**SEQUOYAH NUCLEAR PLANT (SQN) - SENIOR REACTOR OPERATOR (SRO)  
REACTOR OPERATOR (RO) LICENSING EXAMINATIONS**

This letter provides our comments concerning questions on the written licensing examinations administered on August 21, 2000. Specifically, we are requesting your consideration to accept two possible answers on four questions. Enclosure 1 includes the examination questions and the basis for this request. Also, additional information concerning two of the job performance measures is being provided in Enclosure 2. These comments were discussed with the chief examiner, Charles Payne, on August 24, 2000.

Sequoyah Nuclear Plant  
August 2000 NRC Written Exam

Changes to exam questions based on SQN post-exam review

Two Phase Operation of Containment Spray System  
Core Damage Figure 2

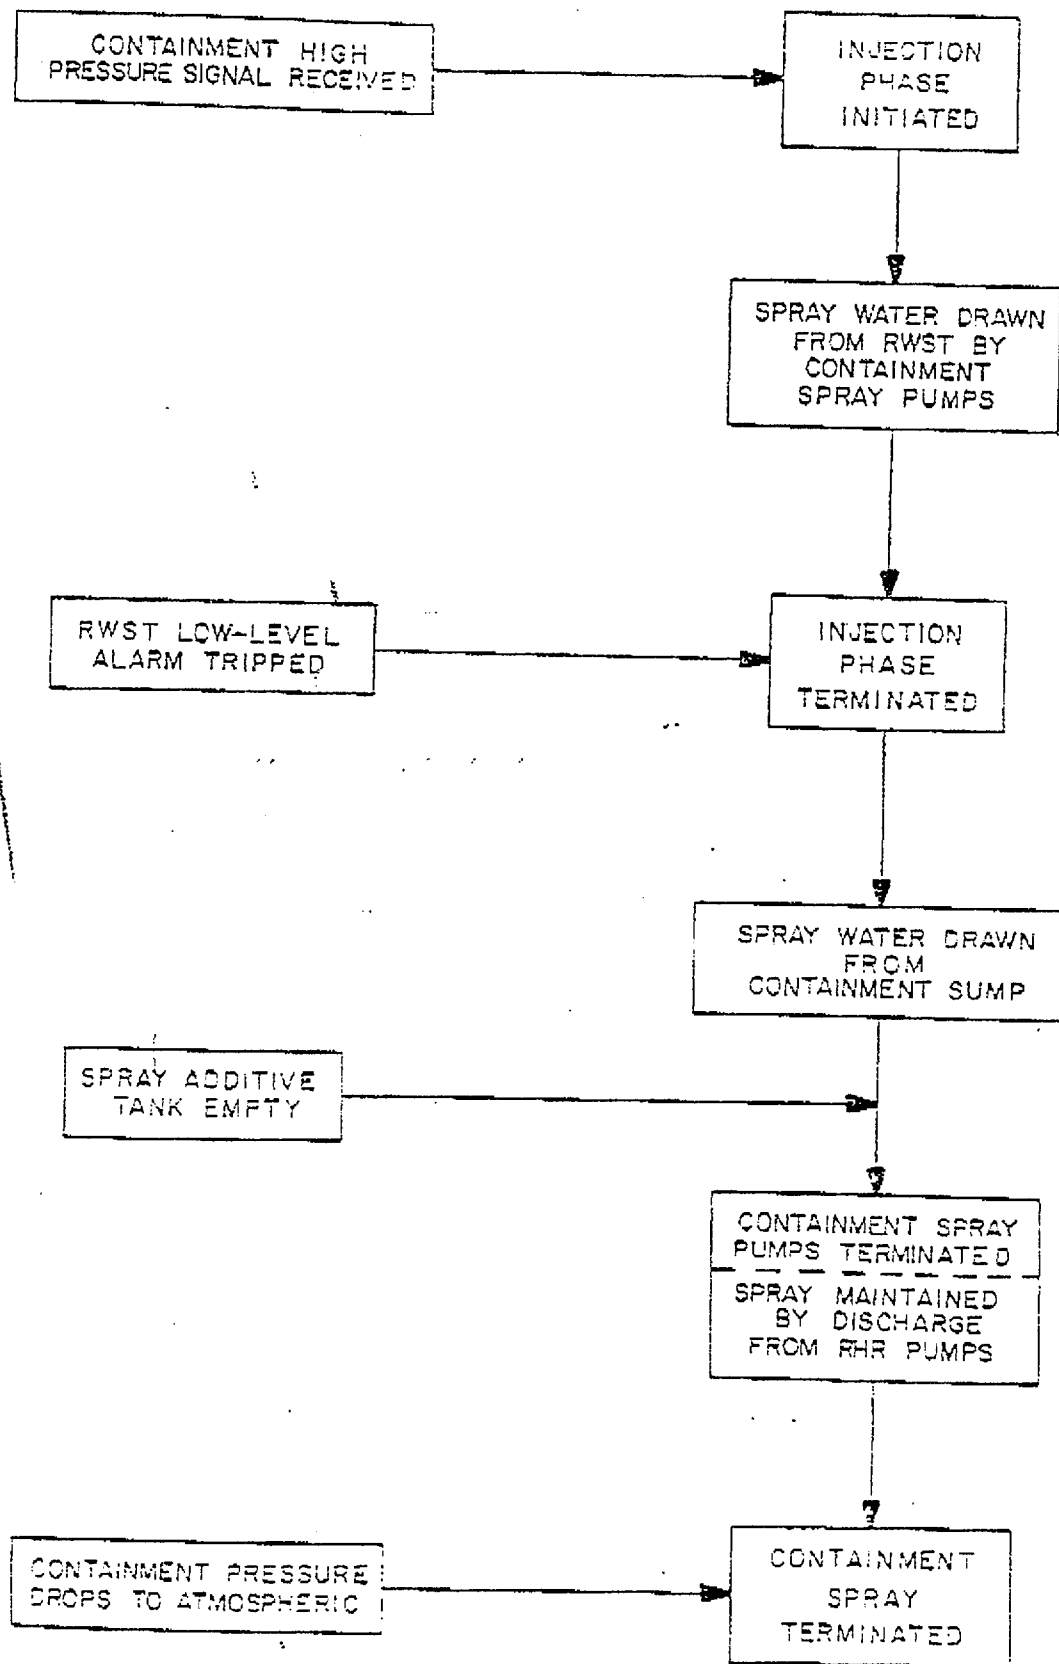
The containment spray system operates in two sequential phases, as illustrated in the flow chart of Figure 2. The first phase, known as the injection phase, is an immediate automatic response to a break, and is initiated by a containment high pressure signal. In this phase, borated water is drawn from the refueling water storage tank (RWST) by
